Service Bulletin

PI0904

Subject: Windshield Wiper Motor Service Part Update

Models: 2008-2012 Chevrolet Express 2008-2012 GMC Savana

3255935

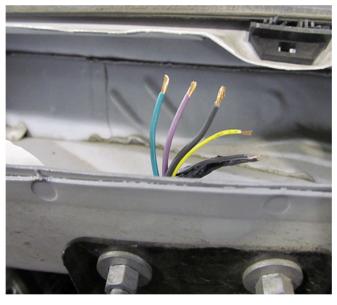
2. With the wiper motor harness in a serviceable position, remove the wiring harness protective wrap as required to access the wiring.

3. With the wires exposed, Measure 50 mm (2.0 in) from the connector as shown. Cut all five wires at this location and remove the existing connector.

3255980

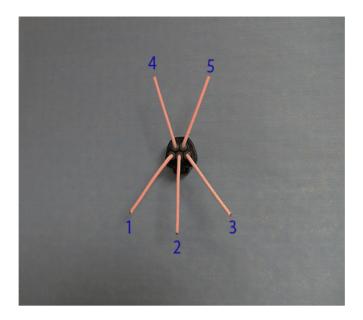
5.1. Measure 50 mm (2.0 in) from the connector as shown. Cut all five wires at this location.
